## Engineering Department Staff Report Memo

**To:** Edie Berghoff, Associate Planner  
**From:** Michael Bateman, PE | Transportation Engineer  
**Subject:** Preliminary Plat Engineering Staff Report | Plateau at Liberty Bay PRD | P-12-06-22-02  
**Attachments:** Engineering Department Recommended Conditions of Approval dated March 14, 2024  
 Public Works Department Recommended Conditions of Approval dated March 14, 2024  
**Date:** March 28, 2024

## Engineering Department SEPA Memo

**To:** Heather Wright, SEPA Responsible Official  
**From:** Michael Bateman, PE | Transportation Engineer  
**Subject:** SEPA RECOMMENDATION | Plateau at Liberty Bay PRD | P-12-06-22-02  
**Date:** March 28, 2024

Figure TR-3, Land Use Comprehensive Plan,  
Transportation Element

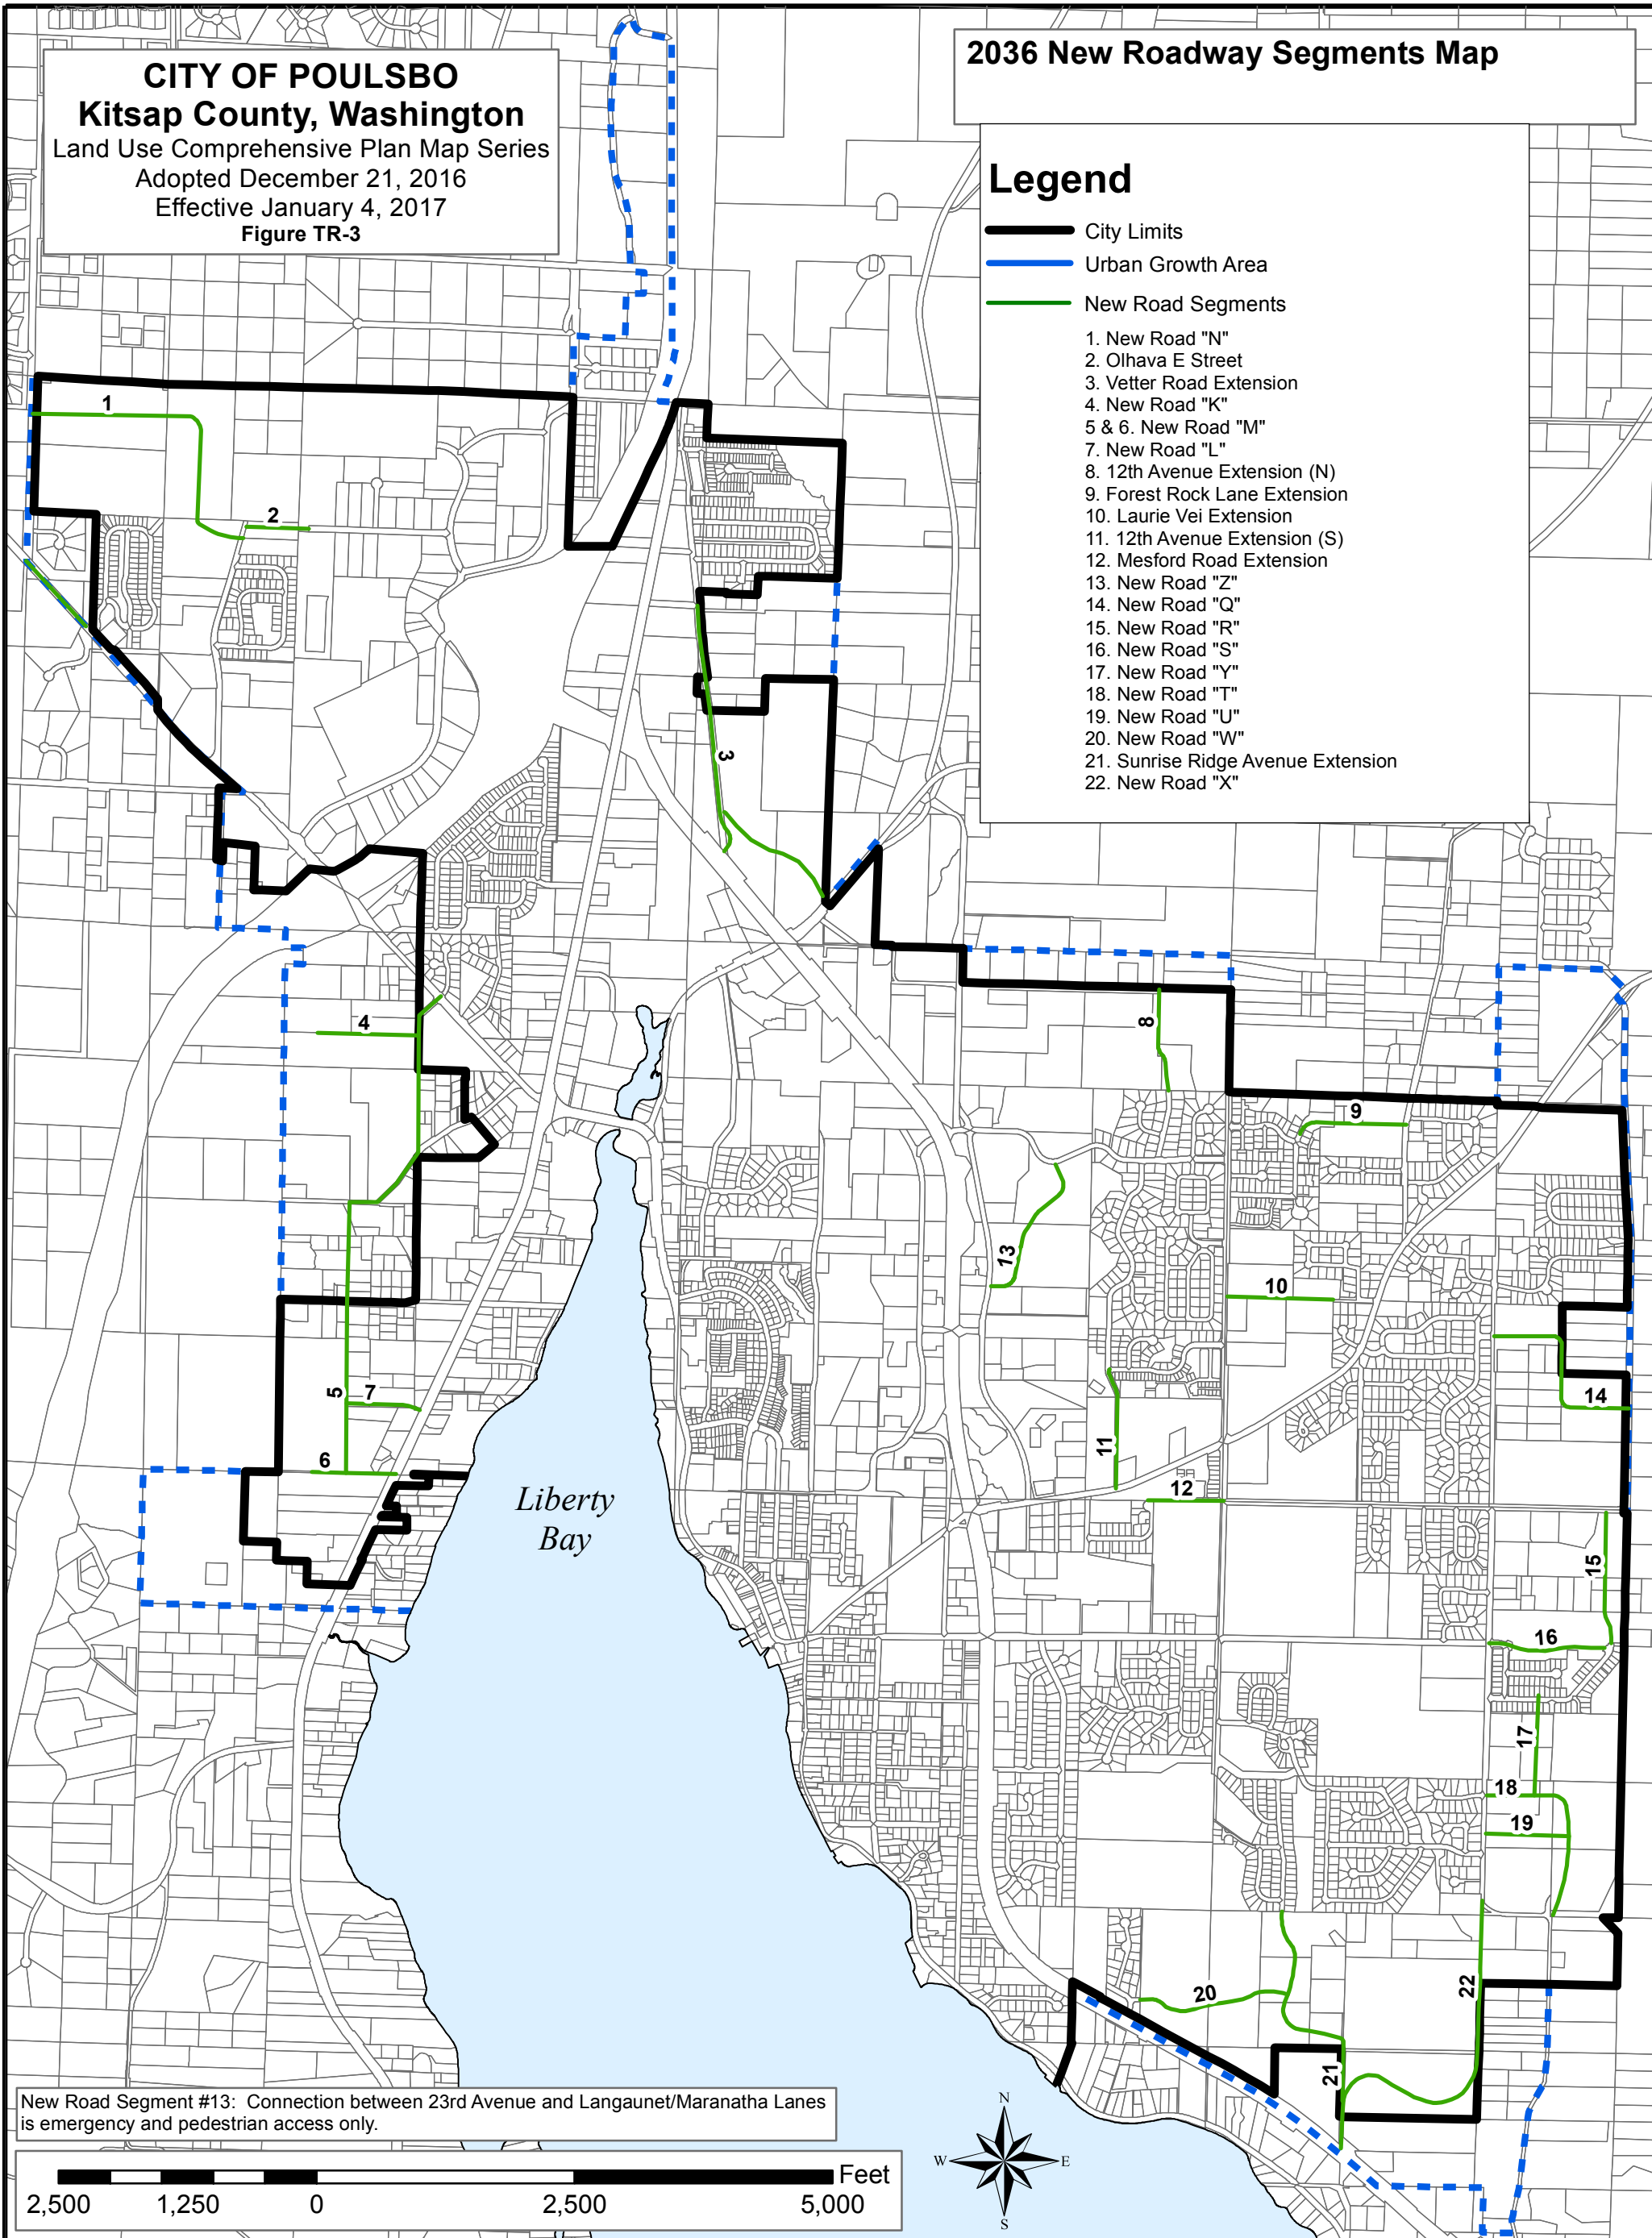
The City's Comprehensive Transportation Plan Update section 6.1.1 and City Comprehensive Plan Chapter 4 New Roadway Segments Map Figure TR-3 show required collector/sub collector level roadway connections. Development projects are required to meet the intent of these new roadway connection requirements within the project and provide and/or provide accommodation for these future roadway connections.

This project's primary roadway network within the site provides for completion of required Figure TR-3 New Roadway segments numbers 5 and 7 within the project site, provides for future completion of New Roadway segment number 5 offsite to the North via the secondary emergency access road connection to NW Liberty Road, and provides for accommodation of future roadway

connection number 6 on the project's southern border.

Staff has analyzed the requirements of PMC 17,80.050, 17.80.060, City Construction Standards, City Transportation Plan, City Comprehensive Plan, International Fire Code and City Water Comprehensive Plan requirements and determined that as-proposed in the project documentation the proposed roadway network connections and future roadway network stubs provided will adequately satisfy these requirements.
